Appendix C : Stakeholder Post-Workshop Design Update Pack

Havant Thicket Reservoir

Phase 7 & 8 Reserved Matters

Western Rush Pasture Basin

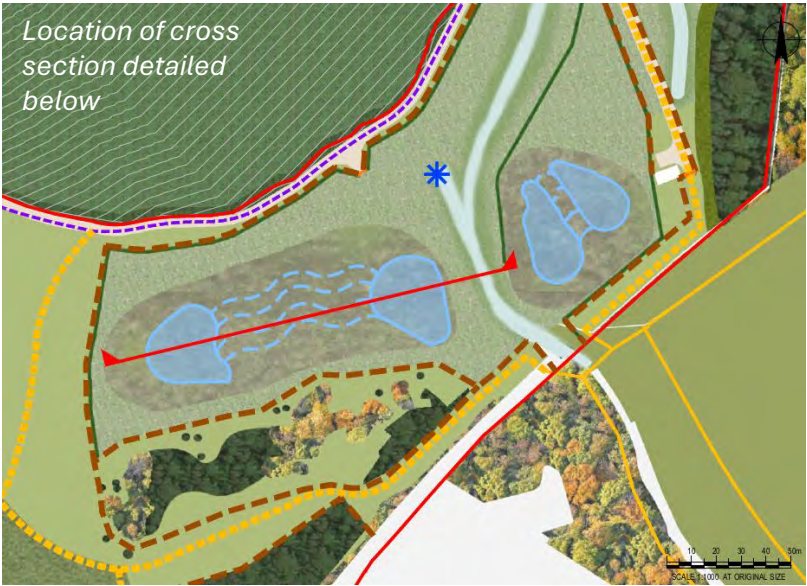
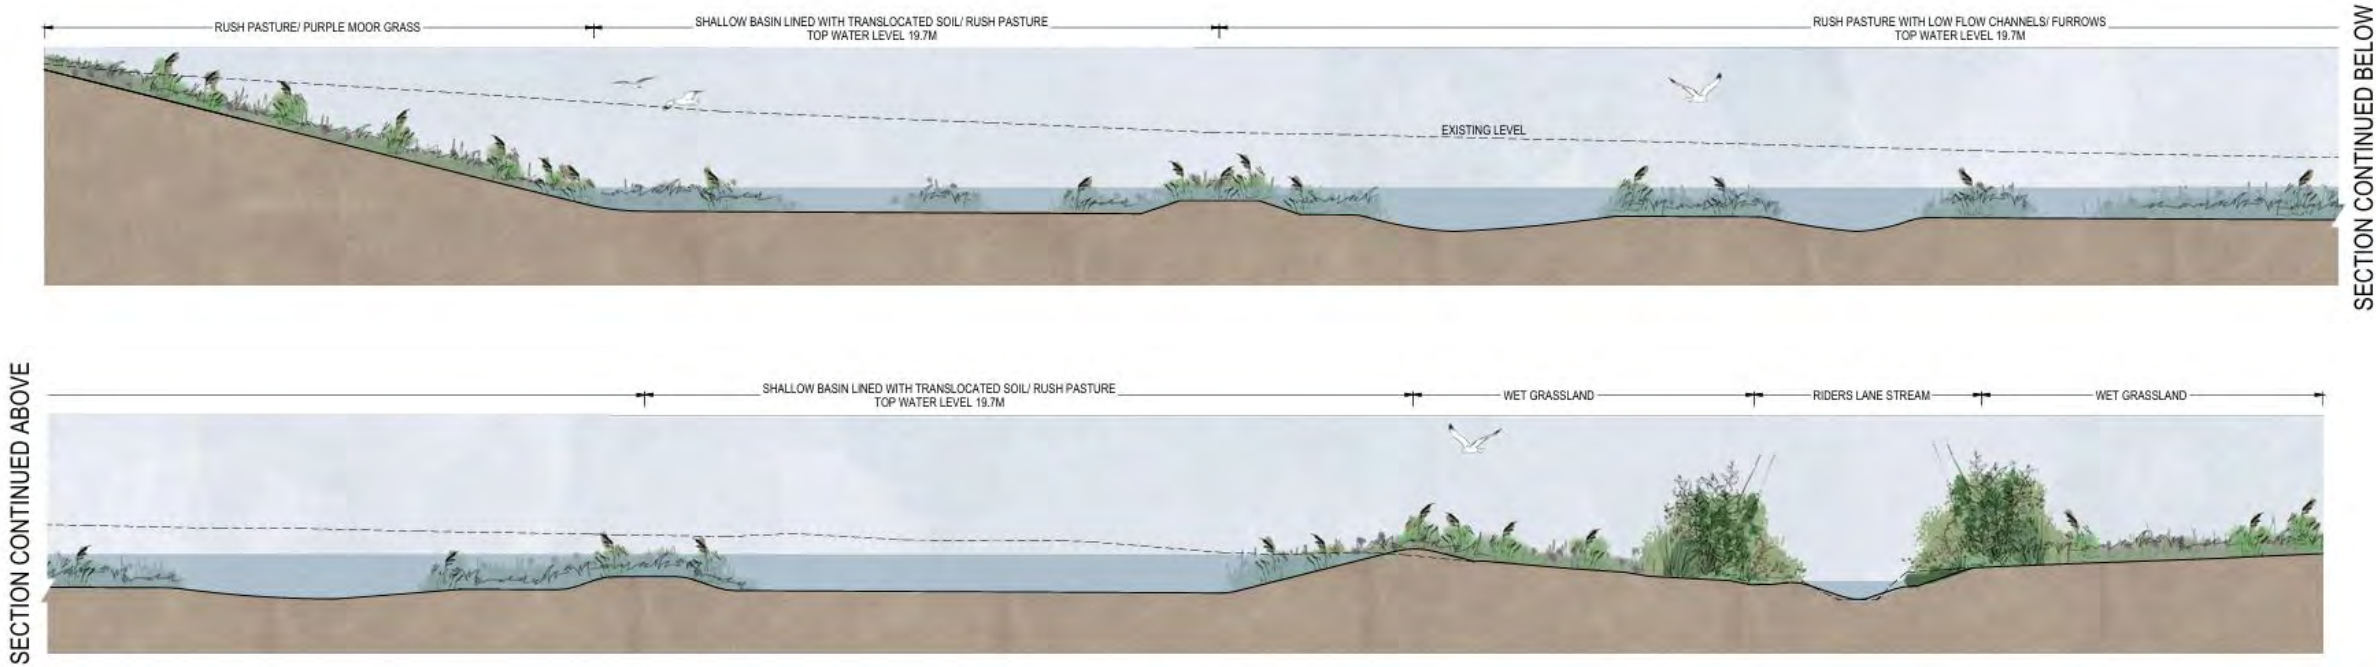
Stakeholder feedback provided on the interface between the rush pasture basins and realigned Riders Lane Channel indicated a preference not to have a bund between the basins and the channel or for the height of this to be reduced.

A bund was placed between the rush pasture basins and Riders Lane Channel to retain water in the basins and provide optimal conditions for the development of wet grassland. However, following feedback provided, this has been lowered in height and smoothed out to create a more natural transition and opportunity for the establishment of wet grassland habitat on its gentler slopes.

Western Rush Pasture Basin

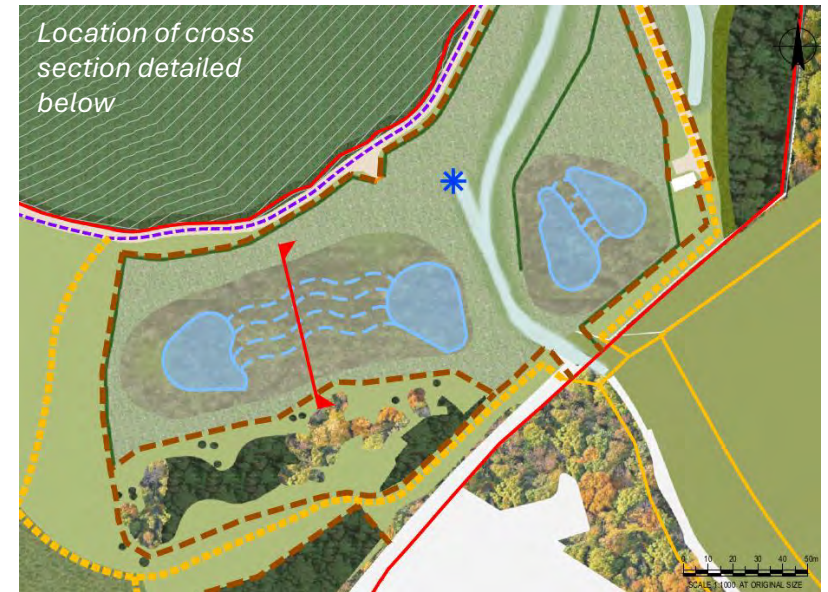
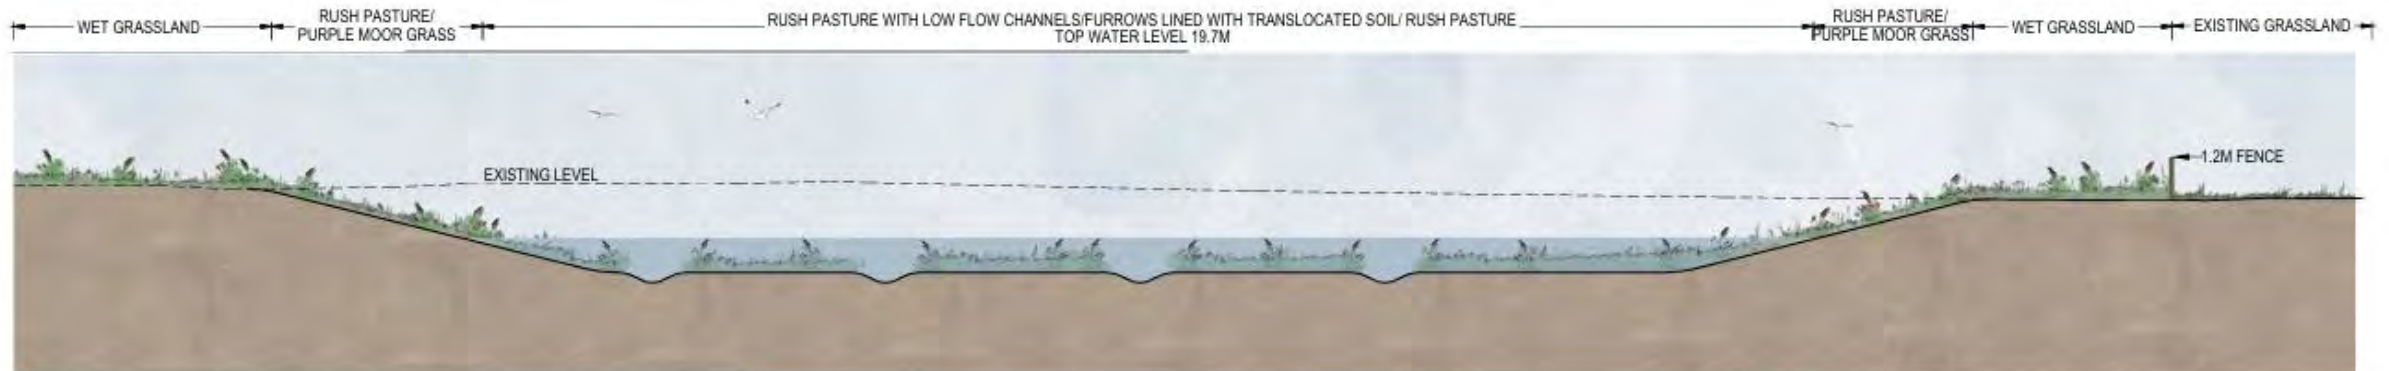
Stakeholder feedback provided on the low flow channels within the swale basins queried whether bunds would be utilised between channels.

Low flow channels will be achieved in the rush pasture basin by a series of furrows as depicted in the below cross section taken from across the centre of the western rush pasture basin. This will allow seasonal variation in moisture levels across the basin, supporting establishment of translocated soils and creating habitat diversity.

By utilising a system of furrows no bunds are required within the basin as the furrows will naturally create a variety of create wetter channels and drier raised areas seasonally.

Eastern Rush Pasture Basin

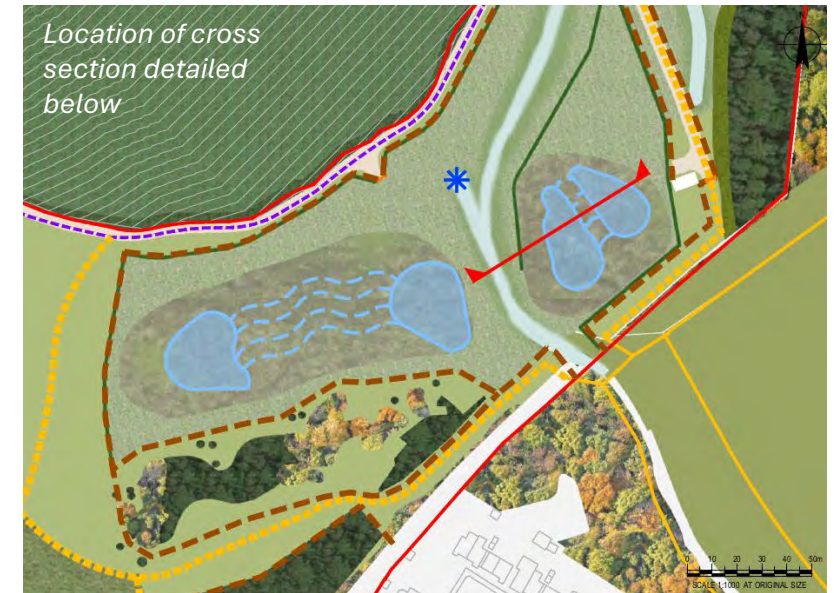
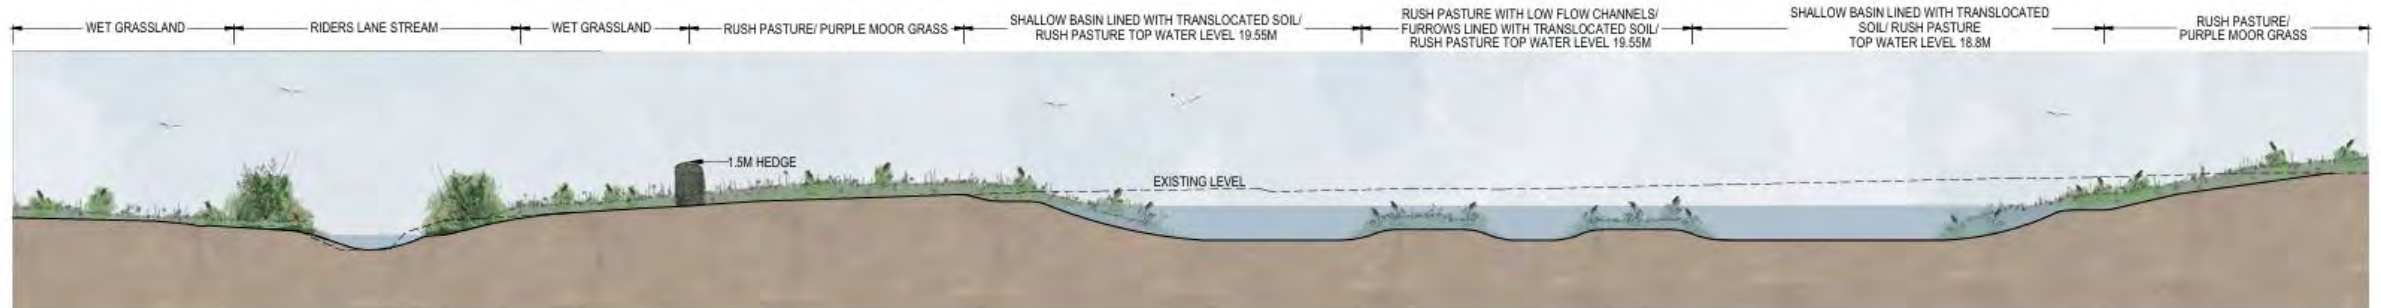
Stakeholder feedback suggested directing embankment toe drainage and surface water drainage into the rush pasture basins to help keep the areas wetter and optimise biodiversity potential.

An additional suggestion was also made to connect the drainage channel east of the eastern basin directly to the basin.

Both the western and eastern rush pasture basins will receive water from the drainage systems (which combine embankment toe drainage and surface water drainage) on their respective sides of the reservoir site.

Although the eastern drainage system runs into the drainage channel east of the eastern basin, it is not possible to directly connect this to the basin due to the implementation of a requested footpath route. The water will therefore flow from the eastern drainage system into the drainage channel to slow down flow rates and then be culverted under the footpath into the rush pasture basin.

Realigned Riders Lane Channel

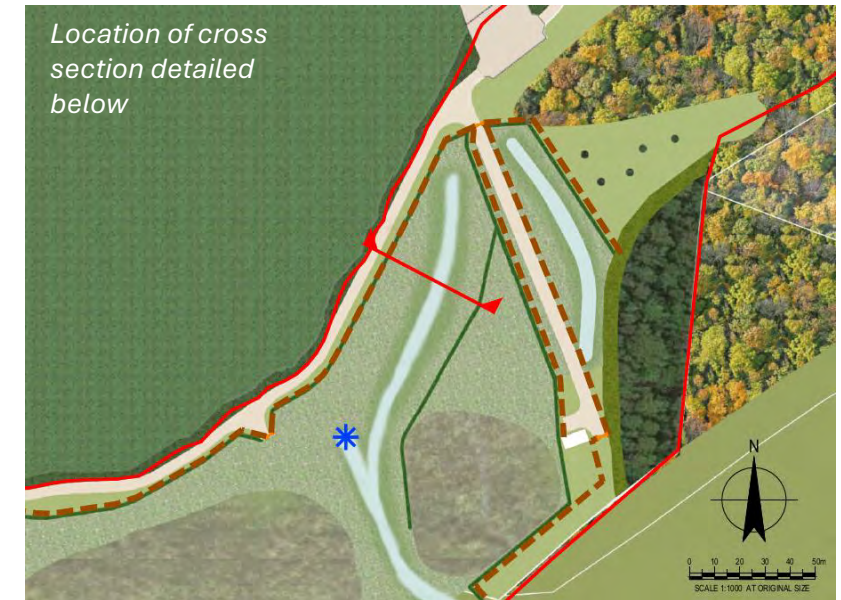
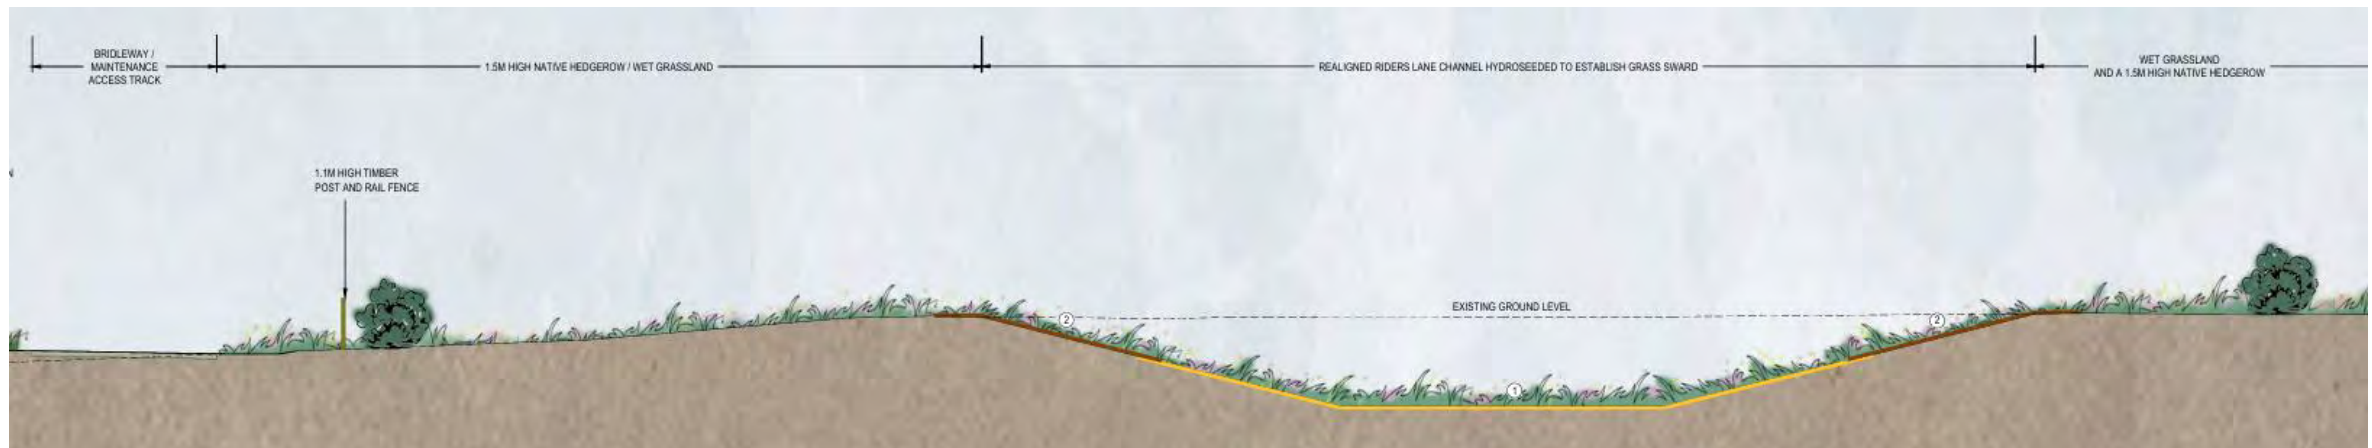
Stakeholders feedback requested more information be provided about planting within the realigned Riders Lane channel.

The realigned Riders Lane channel provides required compensation flows for Riders Lane stream but must also be able to be used as one of the routes for water to leave the reservoir during an emergency draw down scenario. It therefore needs be able to withstand high velocity flows and wave action against its slopes without eroding.

The design of the channel is as follows (see below cross section for detail):

- Hydroseeded geotextile layer with 100% coconut fibre
- Hydroseeded Enkamat geotextile supplemented with plug planting to create a naturalised channel in accordance with LEMP requirements

Eastern Wildlife Corridor

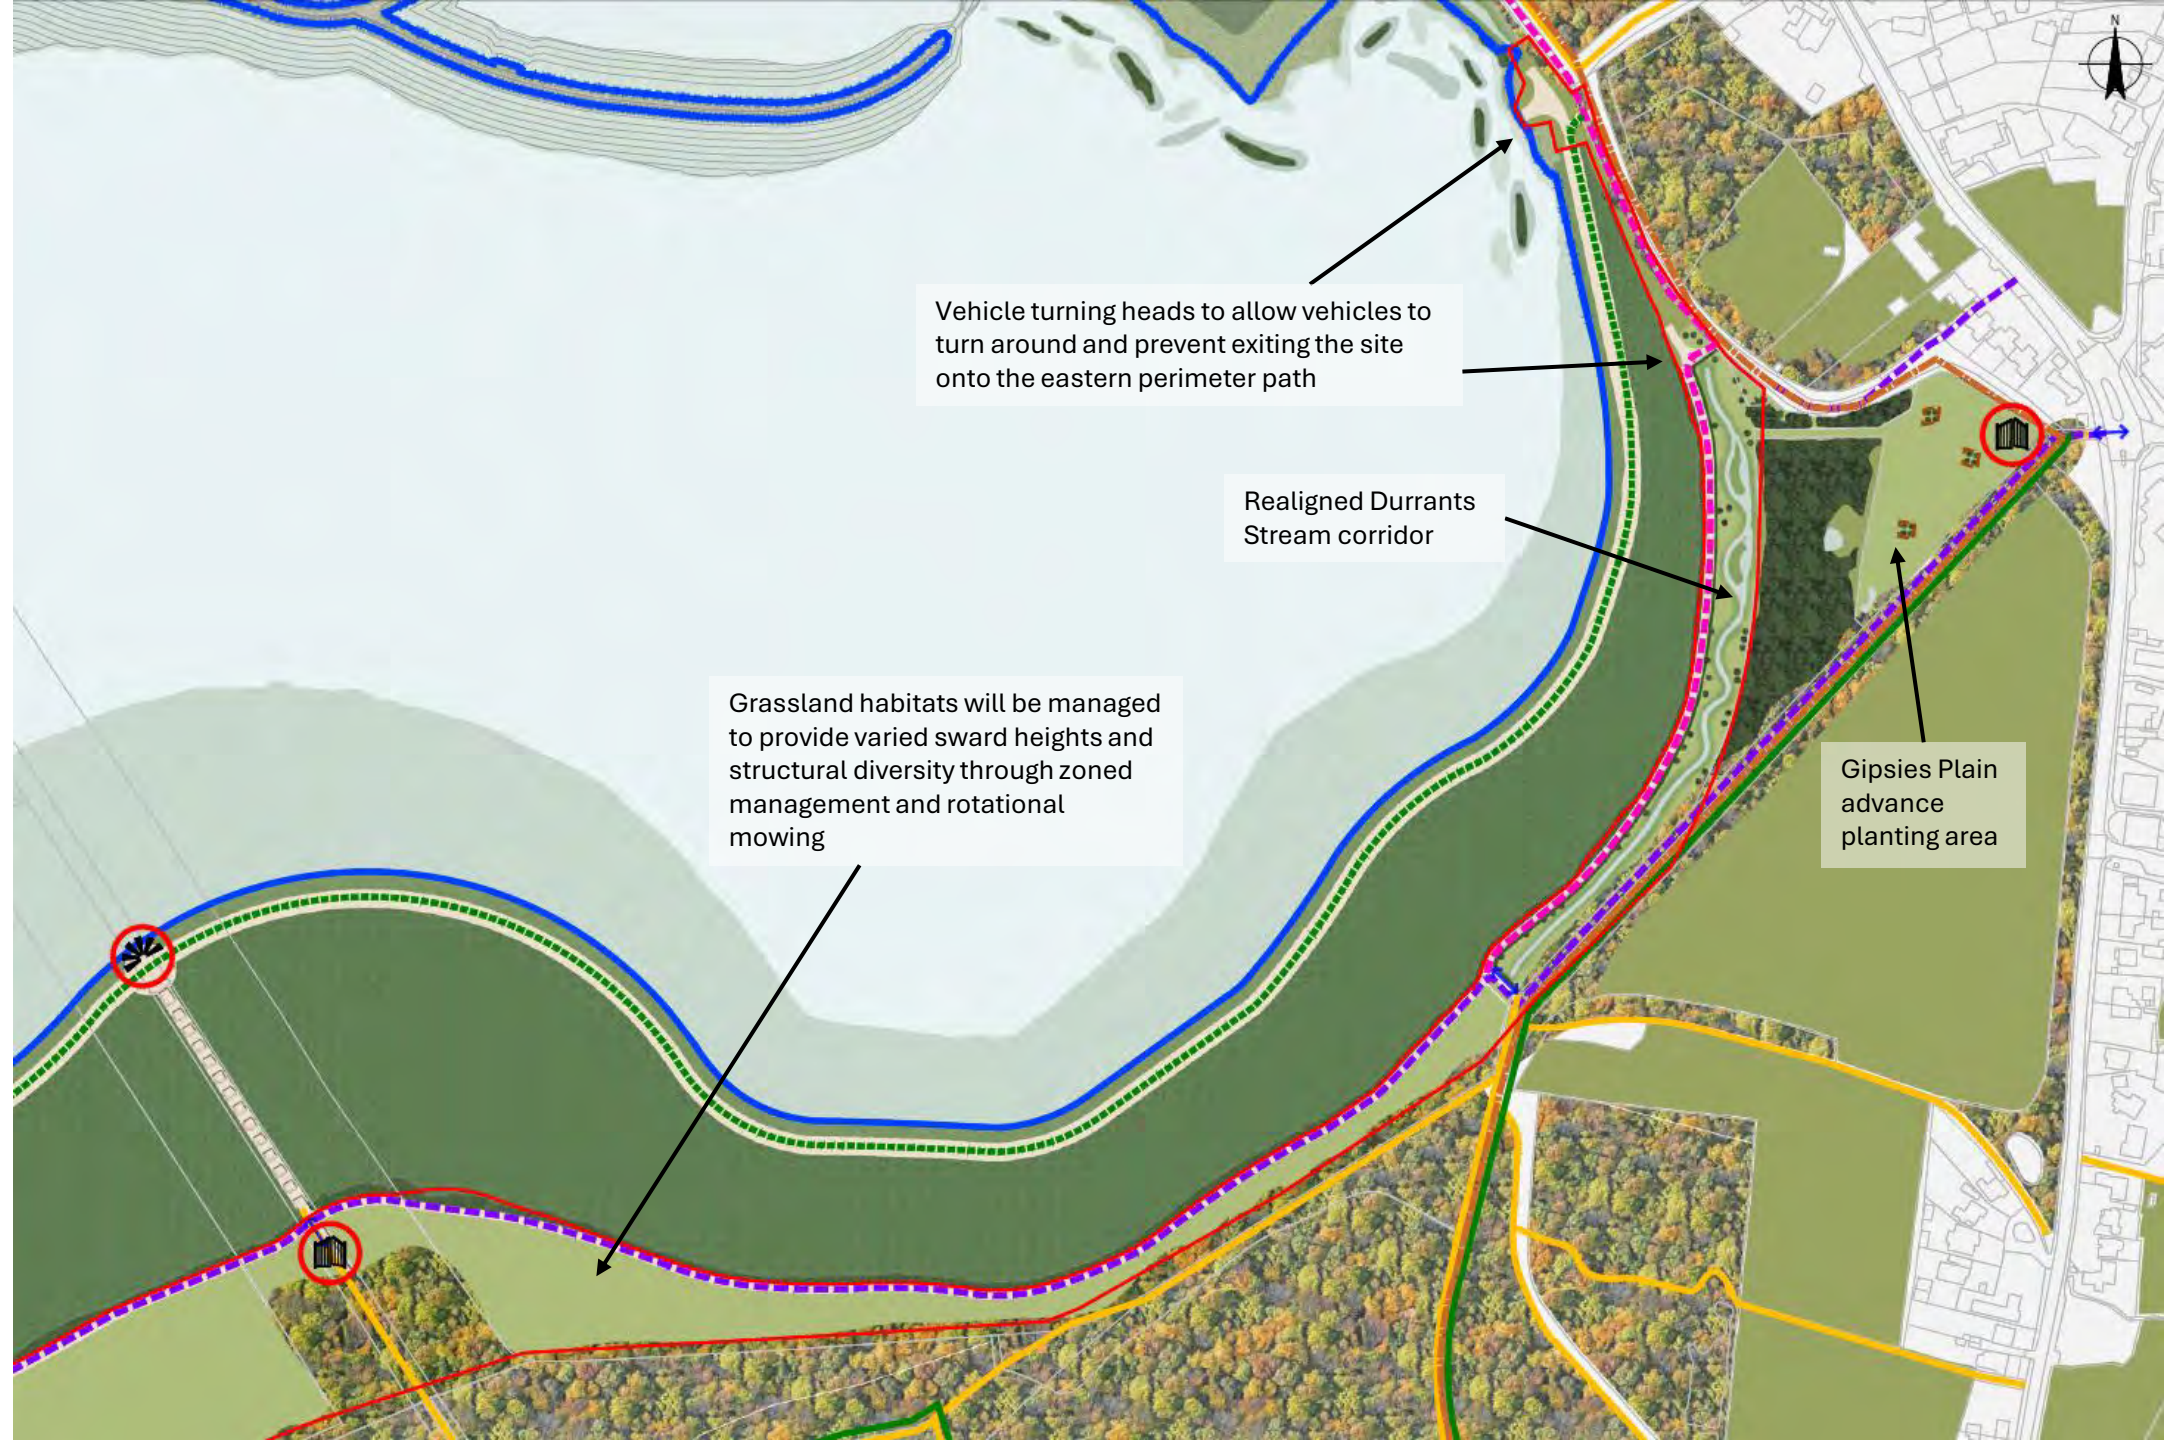
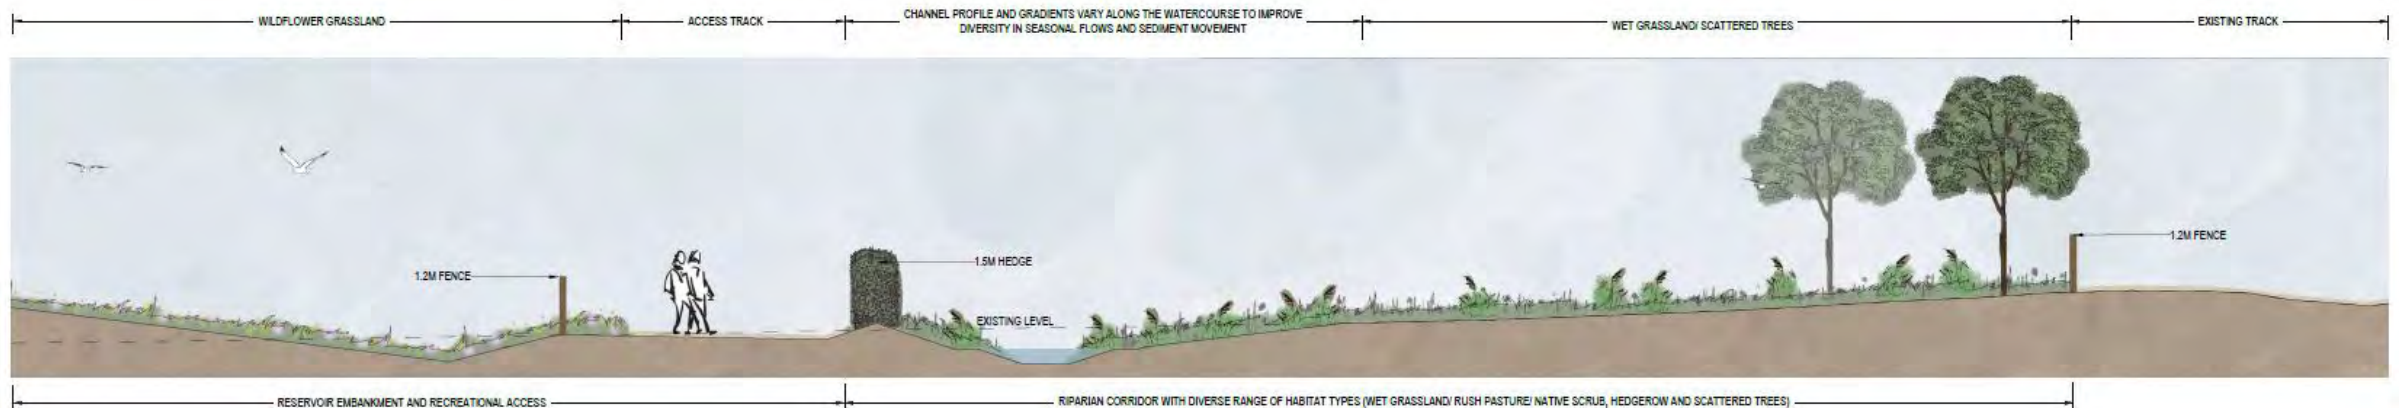
Stakeholders feedback requested information be provided relating to enhancement of the eastern wildlife corridor.

Proposals for planting and connectivity along the eastern wildlife corridor are now fully detailed on drawings, including a mixture of native hedgerow and scrub, wet grassland and tree planting. Plans also detail all advance planting already undertaken along the eastern site boundary and within Gipsies Plain (which is outside of the Phase 7 & 8 Reserved Matters Application boundary) in order to clearly show the bolstered connectivity along this route.

Included below is a cross section of the eastern wildlife corridor depicting the embankment toe track, realigned Durrants Stream corridor (covered further on page 13) and planting designed to promote a diverse range of habitat types.
